**US Army Corps of Engineers
Omaha District
API 653 Out-of-Service
Inspection Report**

**Andrews Air Force Base, Morningside, Maryland
Facility 5025
Tank 25**

16 January 2018

b. Replace the Floating Pan Perimeter and Penetration Seals

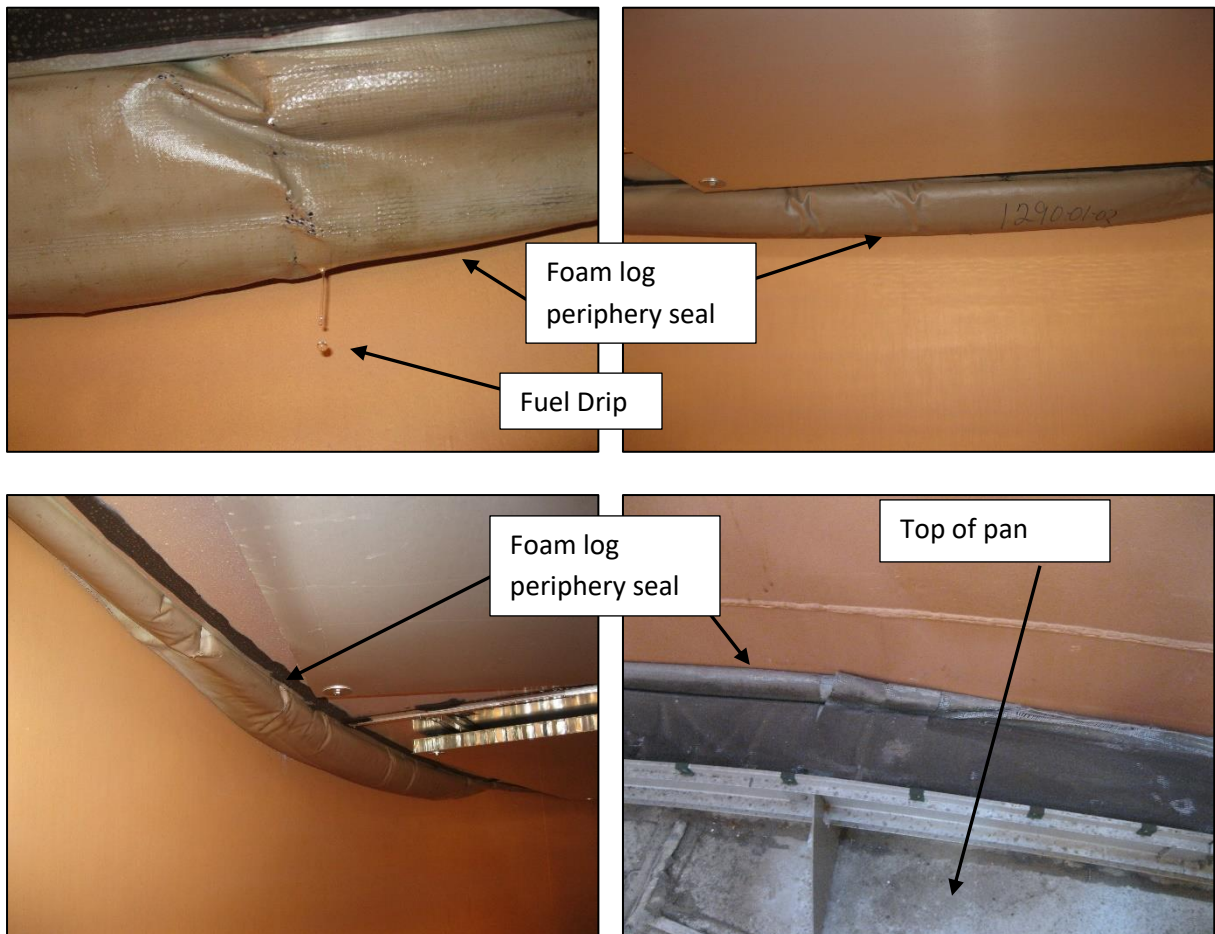
OBSERVATION: The internal floating pan perimeter foam log seal was found to have failed and was dripping fuel all around the perimeter. A ten-foot long section of the foam log perimeter seal is collapsed and is starting to fall apart. The penetration seals are also deteriorated.

REFERENCE: Guidance for new construction provided in DoD Standard Design AW 78-24-27 includes flexible wiper squeegee primary and secondary periphery seals made of closed cell cast urethane.

RECOMMENDATION: Replace the internal floating pan periphery foam log seals with closed cell cast urethane flexible wiper squeegee primary and secondary seals. Replace the floating pan penetration seals with material similar to the periphery seals.

**b. Replace the Cathodic Protection System**

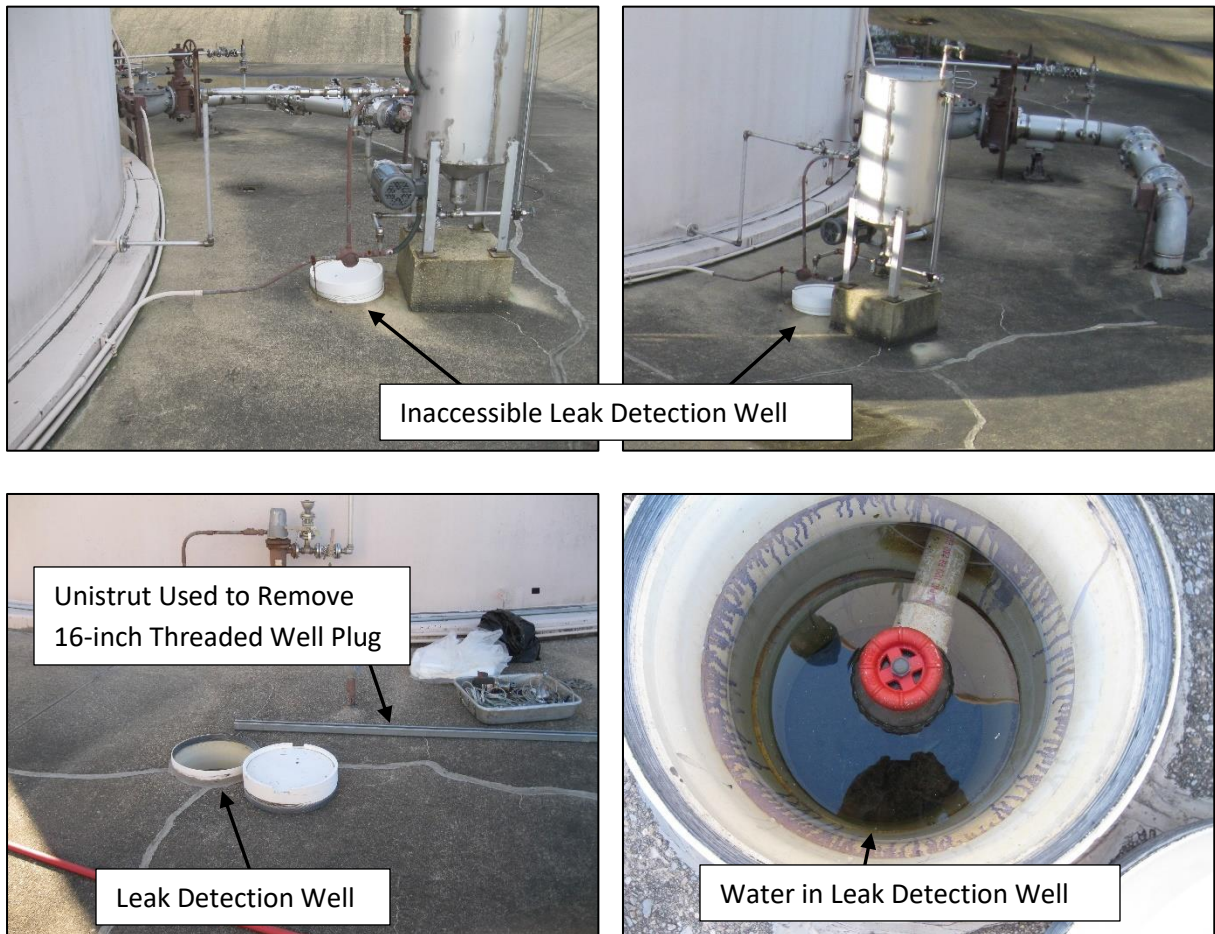
REFERENCE: Guidance for the design of new storage tanks provided in DoD Standard Design AW 78-24-27 and UFC 3-460-01 include cathodic protection under tank bottoms.

RECOMMENDATION: When the tank bottom is replaced, replace the cathodic protection system.

**h. Provide OSHA Compliant Internal Ladder Access Hatch**

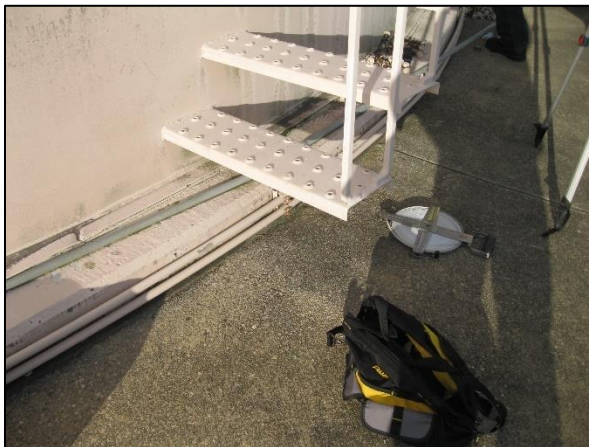
REFERENCE: OSHA regulation 29 CFR 1910.27 (c) requires 30 inches of clearance (24 inches with a deflector plate) on the climbing side of a ladder including at access hatches. Guidance for new construction provided in DoD design Standard AW 78-24-27 includes an OSHA compliant internal ladder access hatch with a rain lip.

RECOMMENDATION: Provide an OSHA compliant internal ladder access hatch with a rain lip.

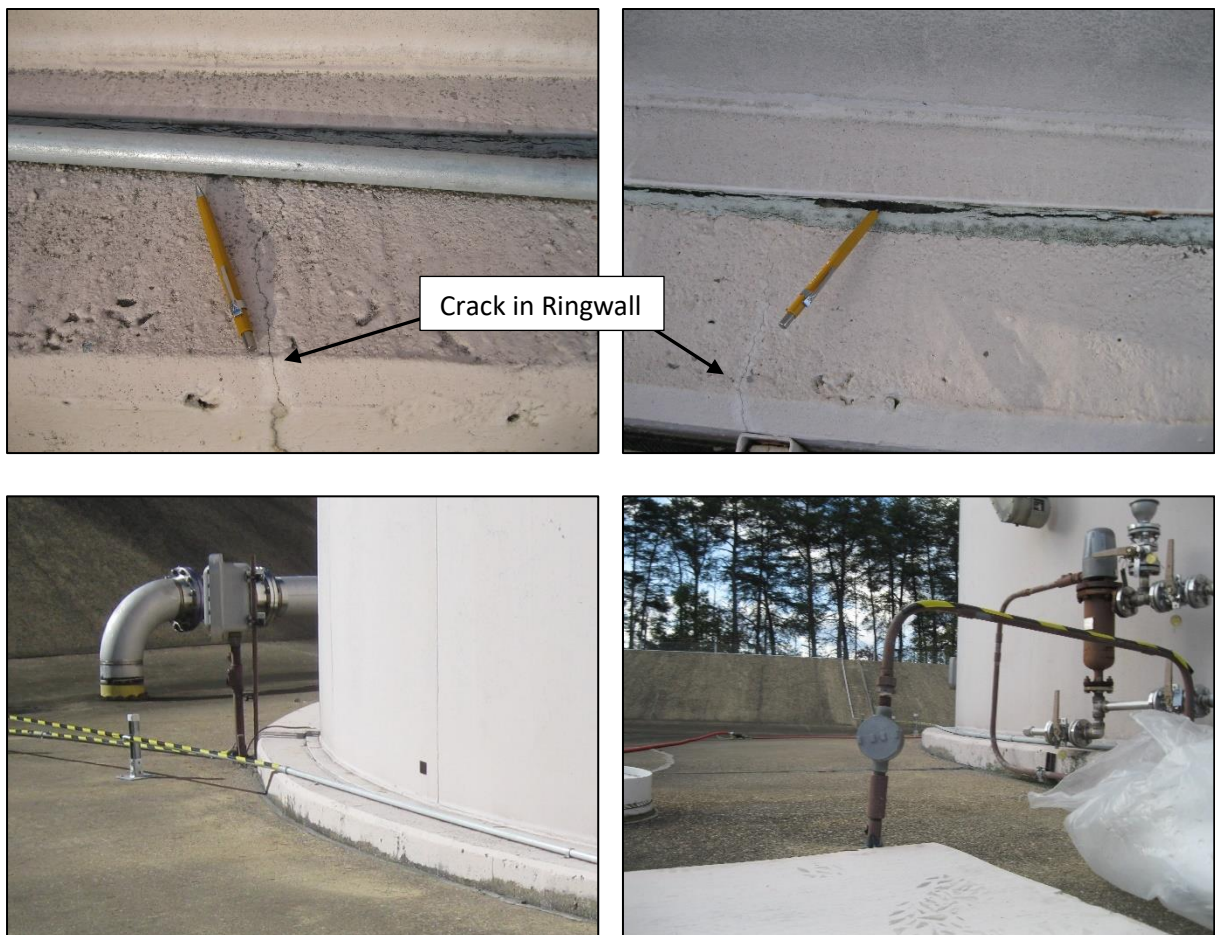
REFERENCE: Guidance for new construction provided in UFC 3-460-01 paragraph 8-3.10 includes coating the exterior. Paragraph 8-3.9 includes coating the interior.

RECOMMENDATION: Replace the coatings on the exterior of the roof including on the floating plug retriever nozzle flange, pan installation hatch cover, the roof guardrail, autogauge guide pipe, interior of the roof manhole cover and flange, and interior of the roof perimeter vent/inspection hatch hoods. Replace the coatings on the receipt and issue DBB valves, and on the level alarm sensor chambers.

**c. Provide API Compliant Internal Pipe Support Mounting Plates**

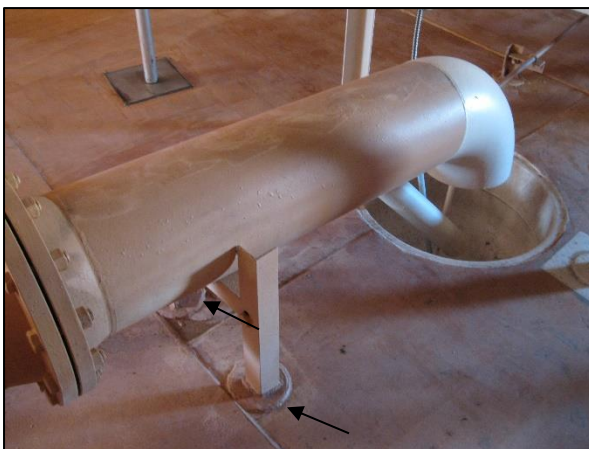
OBSERVATION: Three internal pipe support weld-on base plates are closer than 2 inches to a tank bottom weld seam. In addition, the anti-rotation cable base plate is closer than 2 inches to a tank bottom weld seam.

REFERENCE: In later editions of API 653, paragraph 9.10.3.1 and Figure 9.13 require welds attaching plates to the tank bottom to be at least 2 inches from bottom lap welds. API 653 paragraph 9.10.3.1 allows existing noncompliant weld spacing to be accepted at the time of modification, if the welds are MT or PT examined. The above requirements were incorporated into API 653 some years after the plates were installed, and API 653 does not require MT or PT of existing welds on tank bottoms that do not meet weld spacing requirements but have been in service.

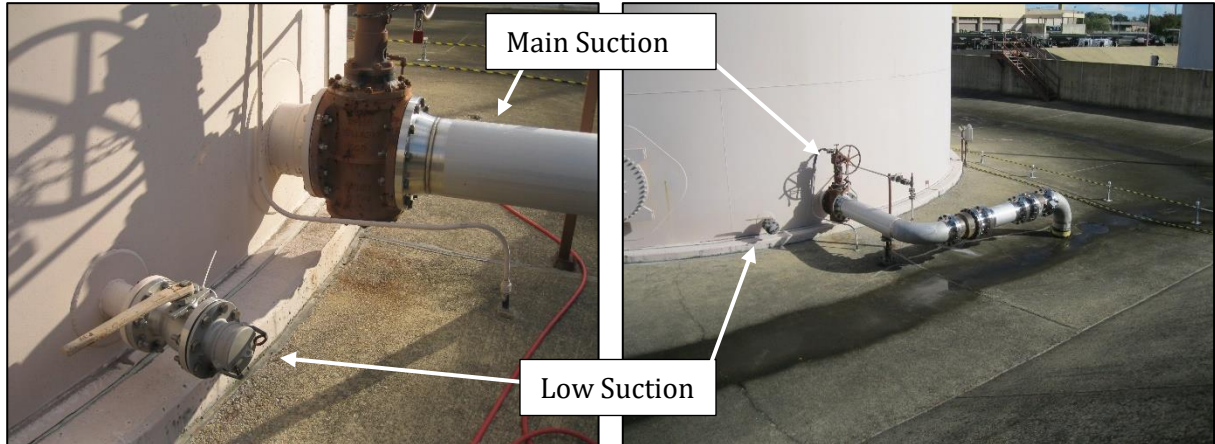
OBSERVATION: The low suction nozzle is not piped to allow using the issue pumps to drain the tank in preparation for tank cleaning and entry. As a result, approximately one thousand gallons of jet fuel that would normally be transferred from the tank into the adjacent tank is wasted every time the tank is cleaned. Considering the value of the fuel and the cost of disposal of the fuel, water, and sludge mixture, the potential loss to the government in 32 years is approximately \$20,000.

REFERENCE: Guidance for the design of new storage tanks provided in UFC 3-460-01 Table 8-1, Item v and DoD Standard Design AW 78-24-26 include hard piping the low suction to the main suction.

RECOMMENDATION: Provide piping and valves to connect the low suction piping to the issue piping.

**e. Provide Removable Mid-rail Chain**

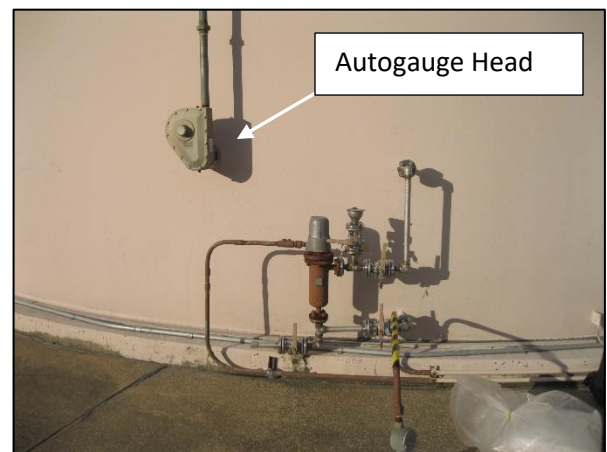
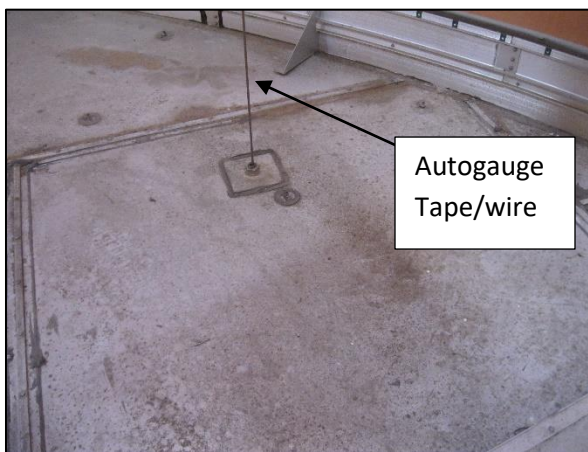
REFERENCE: 29 CFR Part 1910.23 (c) requires every open-sided floor or platform 4 feet or more above adjacent floor or ground level to be guarded by a standard railing. Guidance for design of the new tanks provided in DoD Standard Design AW 78-24-27, includes a guardrail around the top of vertical ASTs, Detail 1/D.09 indicates a removable intermediate guardrail chain above the perimeter vent/inspection hatches.

RECOMMENDATION: Provide steel angle top rails with removable mid-rail chains above the perimeter vent/inspection hatches.

**g. Provide Exothermic Grounding Connections**

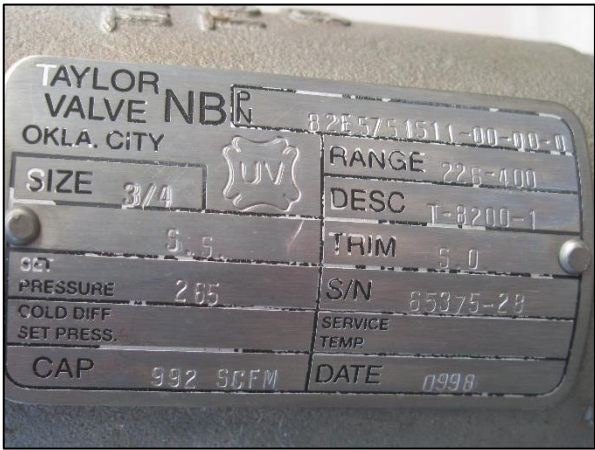
REFERENCE: Guidance for new construction provided in DoD Standard Design AW 78-24-27 Detail 2/ED.02 includes exothermic welding the grounding cables to stainless steel grounding lugs.

RECOMMENDATION: Consider providing exothermically welded grounding connections.

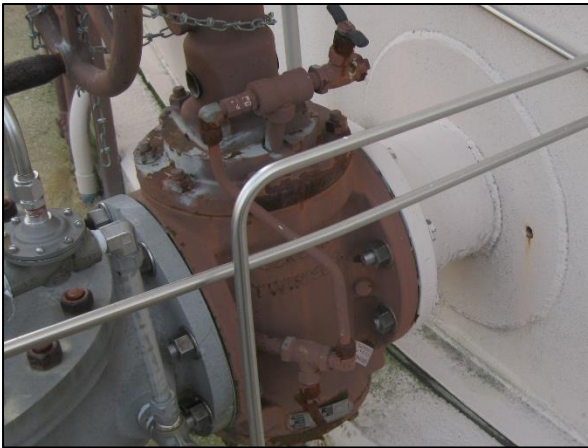
OBSERVATION: The body cavity integral thermal relief valves on the shell nozzle isolation valves are plumbed to relieve away from the tank. The integral thermal relief are differential (not balanced) type and open only when upstream pressure exceeds downstream pressure by a set amount, typically 25 psi. As the thermal relief for the piping is set at 265 psi, the integral relief valves may not open until the internal pressure in the valve exceeds the sum of the set pressures (290 psi).

REFERENCE: Guidance for new construction included in UFC 3-460-01 recommends using balanced thermal relief valves where cascading cannot be avoided.

RECOMMENDATION: Eliminate cascading by replumbing the integral body cavity thermal relief valves on the tank shell nozzle isolation valves to relieve into the tank.

**j. Provide Independent Low and Low-low Level Alarms**

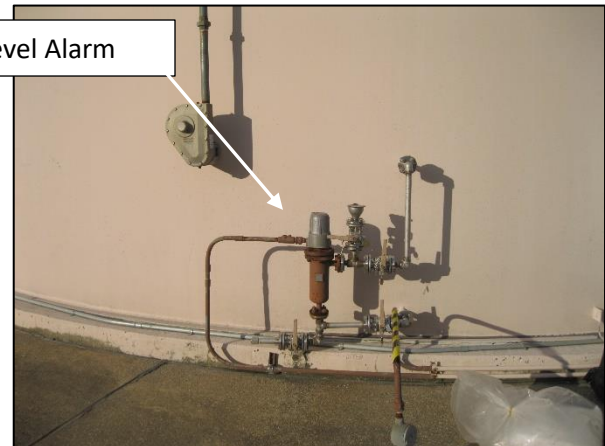
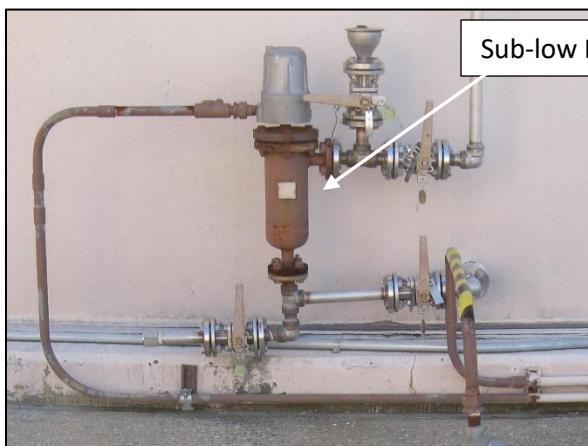
OBSERVATION: Although the level alarm panel indicates a low level alarm, there is no low level alarm above the low leg level of the floating pan. There is however a sub-low level alarm set at approximately one foot below the low leg level of the floating pan.

REFERENCE: Guidance for new construction provided in DoD Standard Design AW 78-24-27 include both high and high-high level alarms as well as low and low-low level alarms above the low leg level of the floating pan. Guidance for new construction provided in UFC 3-460-01, Table 8-1, Item I includes high, high-high, low and low-low level alarms, independent from the tank gauging system.

RECOMMENDATION: Provide low, and low-low level alarms independent of the tank gauging system.

k. Rehabilitate Secondary Containment

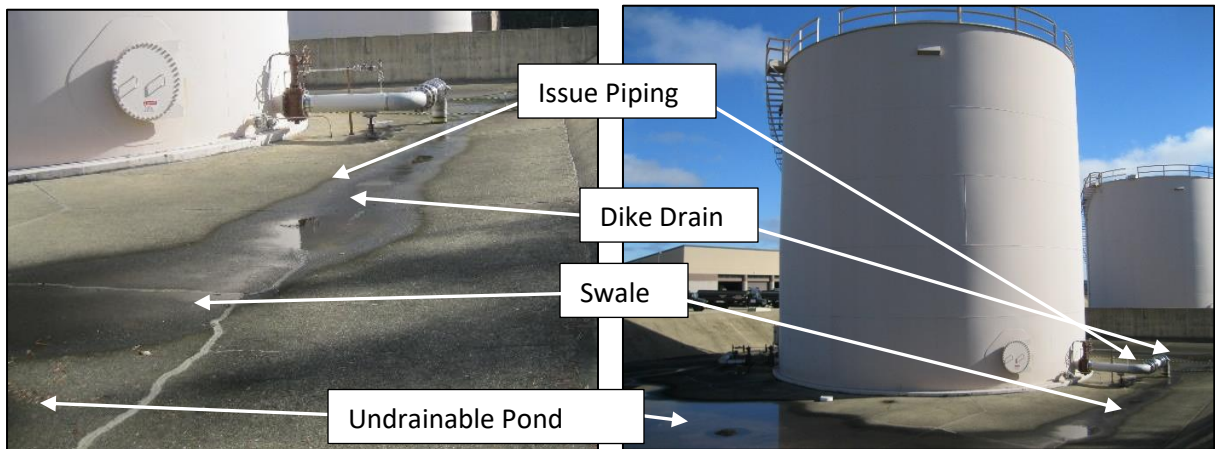
OBSERVATION: The secondary containment basin is sloped to a swale approximately 10 feet from the tank. The issue piping is routed over the swale. A large undrainable pond of rain water collects in the dike area on the side opposite the dike drain. There are numerous cracks in the concrete covering the secondary containment. However, the design drawings indicate a liner under the concrete covering the secondary containment.

REFERENCE: NFPA 30 requires secondary containment to be sloped away from the tank for 50 feet or to the dike wall, whichever is less, and away from product piping for a distance of 50 feet.

RECOMMENDATION: Modify the secondary containment and drain to slope way from the tank all the way to the dike wall, away from the product piping, and to drain the entire dike area.
